**PROPOSED ADDENDUM #1
RFI SCOPE OF WORK**

**GE APPARATUS SERVICE CENTER
TONAWANDA, NEW YORK**

October 7, 1998

RE: Proposed Addendum #1
RFI Scope of Work
GE Apparatus Service Center
Tonawanda, New York

PROPOSED ADDENDUM SCOPE OF WORK

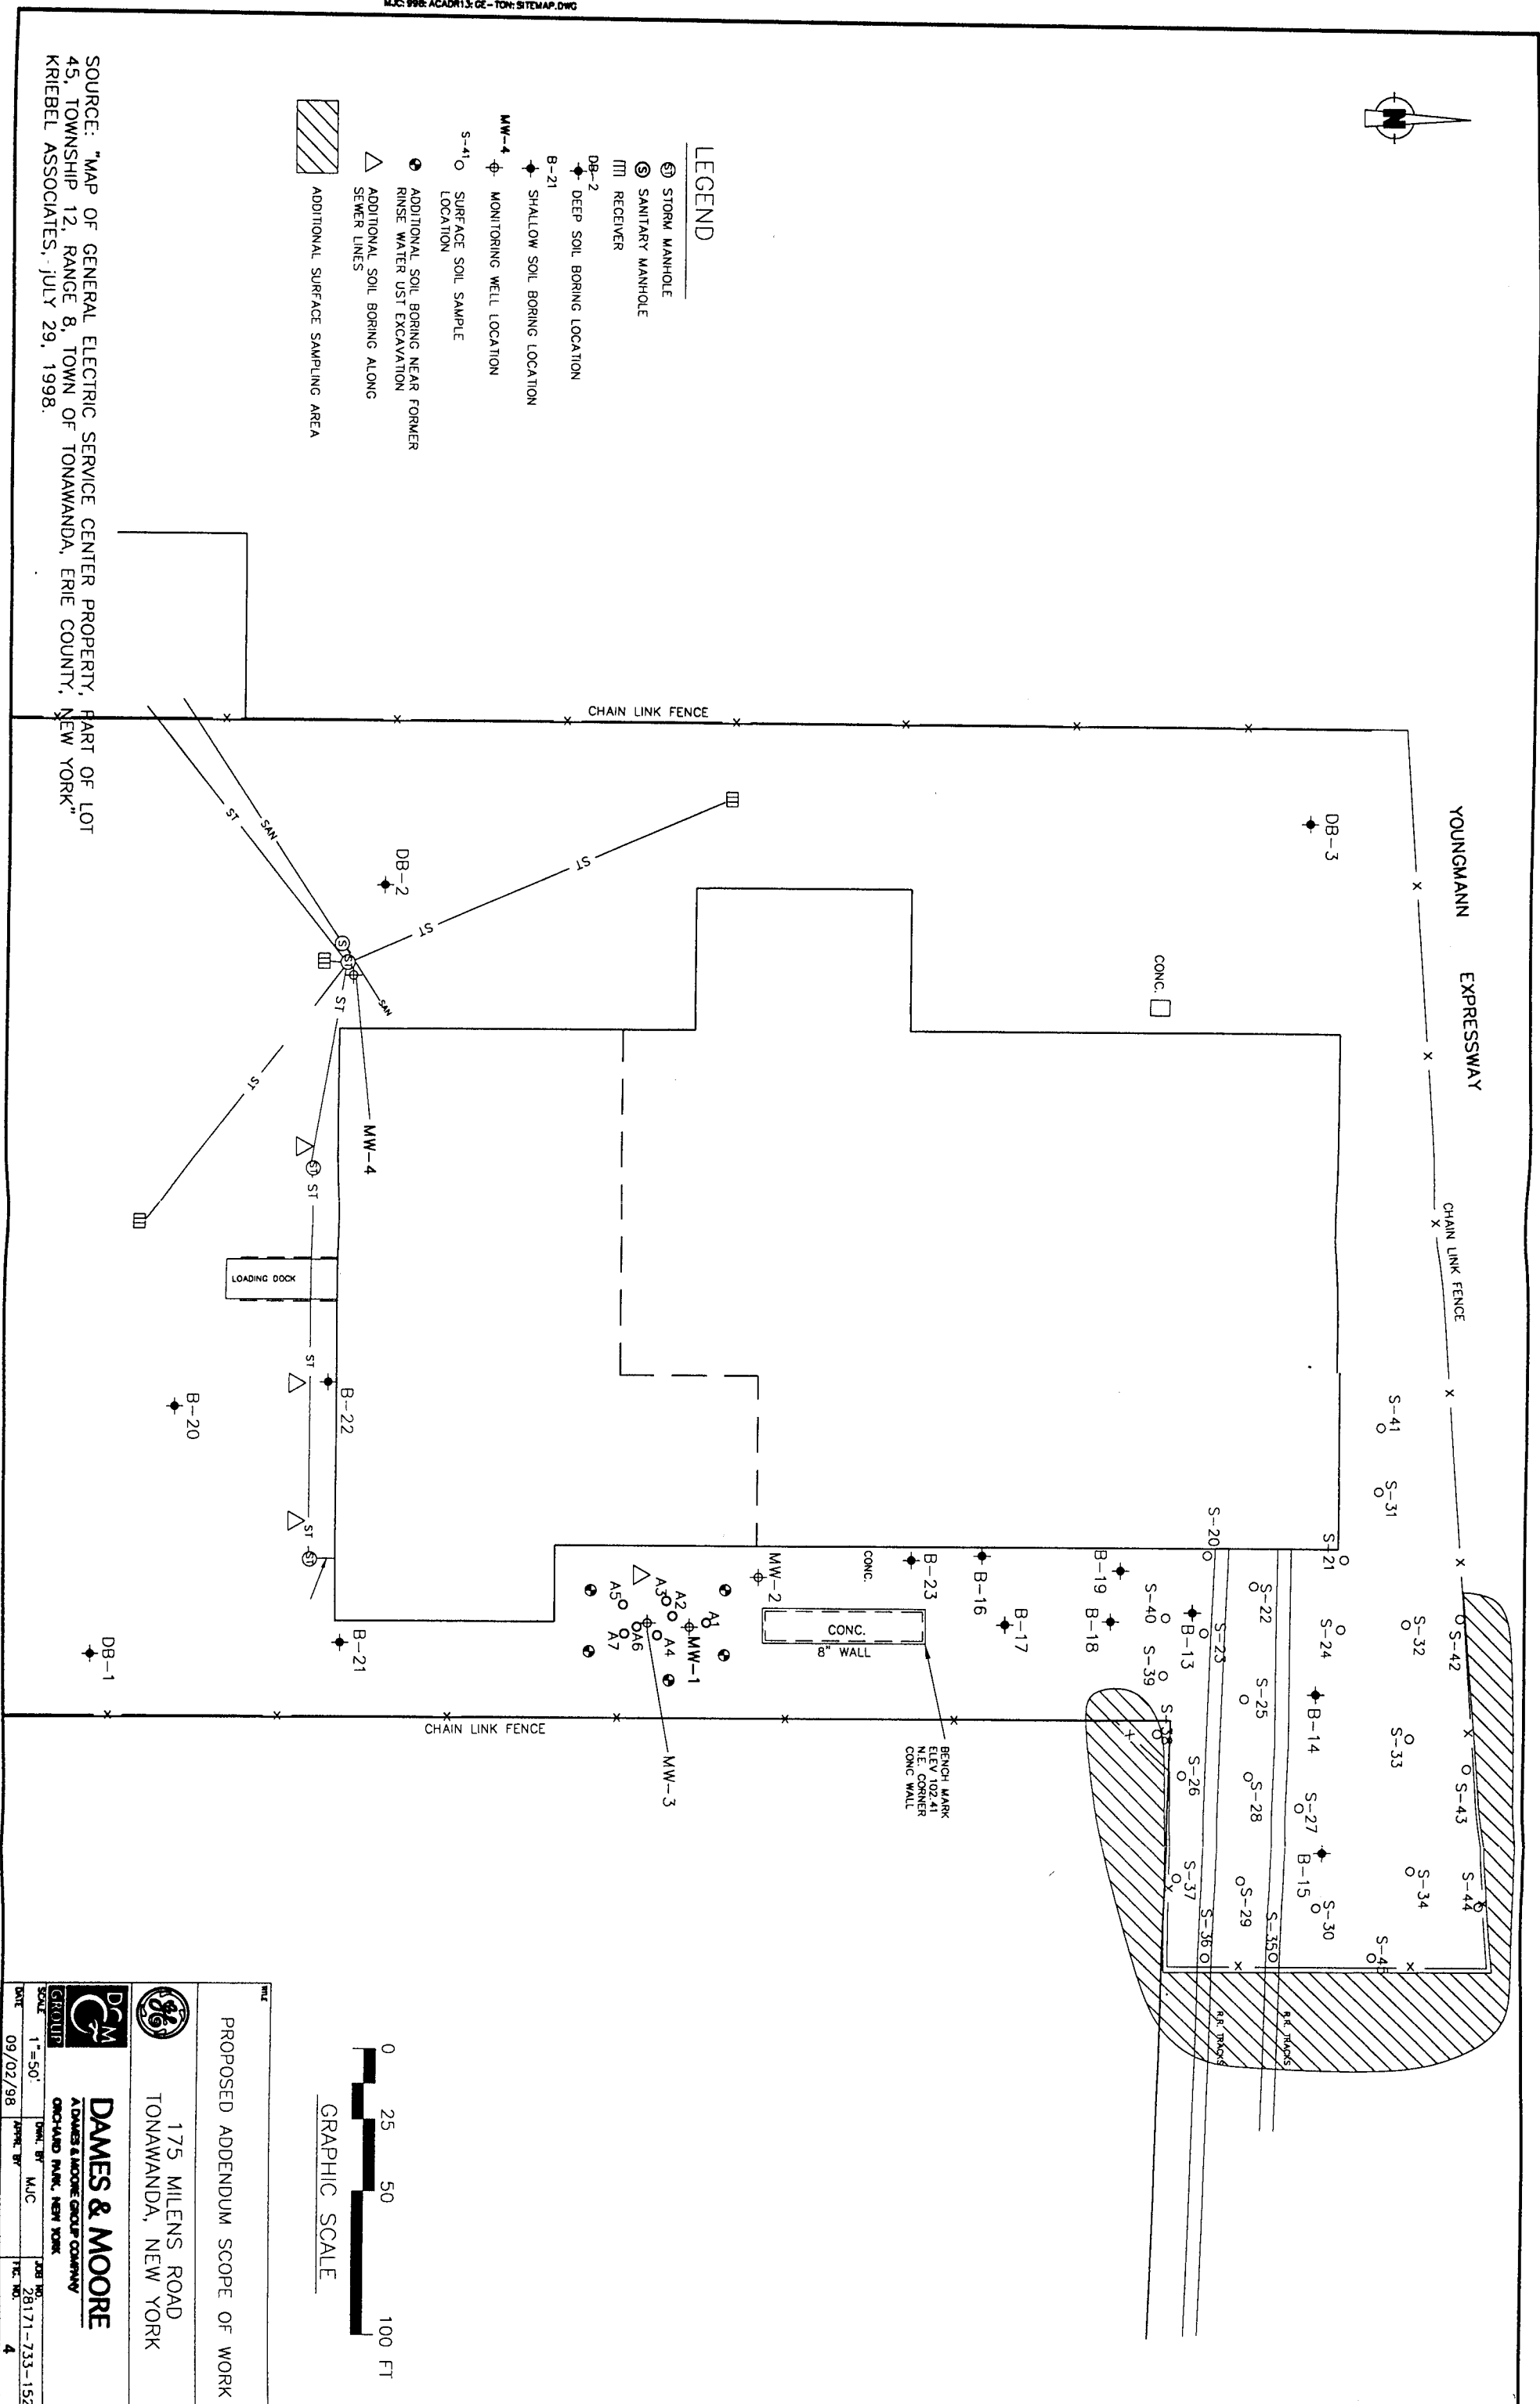
Based on the surface soil sampling results available to date, the extent of soils containing PCBs above 1 mg/kg, which is the NYSDEC's Recommended Soil Cleanup Objective for PCBs in surface soils, has not been defined. Dames & Moore will collect an additional 10 to 15 surface soil samples in the general areas annotated in Figure 4. We anticipate that GE will assist Dames & Moore in obtaining permission from the owners of the adjacent properties (if applicable) to collect surface soil samples off-site.

Based on the soil boring results, the extent of subsurface soils near the former rinse water tank that contain PCBs above the NYSDEC's recommended soil cleanup objective for PCBs of 10 mg/kg in subsurface soils has not been defined. Dames & Moore will install up to five additional soil borings around the former rinse water tank excavation to further define the extent of PCB-contaminated soils. The proposed additional soil boring locations are shown in Figure 4.

will install up to four additional soil borings to further define the extent of PCB-contaminated soils along the sewer lines. The proposed additional soil boring locations are shown in Figure 4.
